Model type:
WIE127XEX

Commercial code:
F030552

Notices

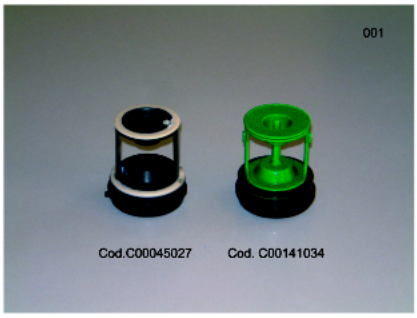
CROSS ELEMENT ASSEMBLY AND SINGLE PARTS MANAGED AS REPLACEMENTS.
SAT code 096077 Cross element assembly with seal rings CV4;
SAT code 096186 Seal ring CV4;
SAT code 013563 Bearing 6205-2Z SKF;
SAT Code 002591 - Bearing 6204-2Z SKF;
On 1200 rpm models, which indicate replacement of the drum with spider in aluminium, with a spider in red ghisa (LVA cod. C00094280 and LVB cod. C00094282), the following pocedure will need to be followed:
1) Remove the upper counter-weight;
2) Position the balancing springs inside the support holes found further back than the previous position on the cabinet (see fig.001);
3) Affix the shock absorbers on the support holes positioned on the back part of the cabinet (see fig.002).
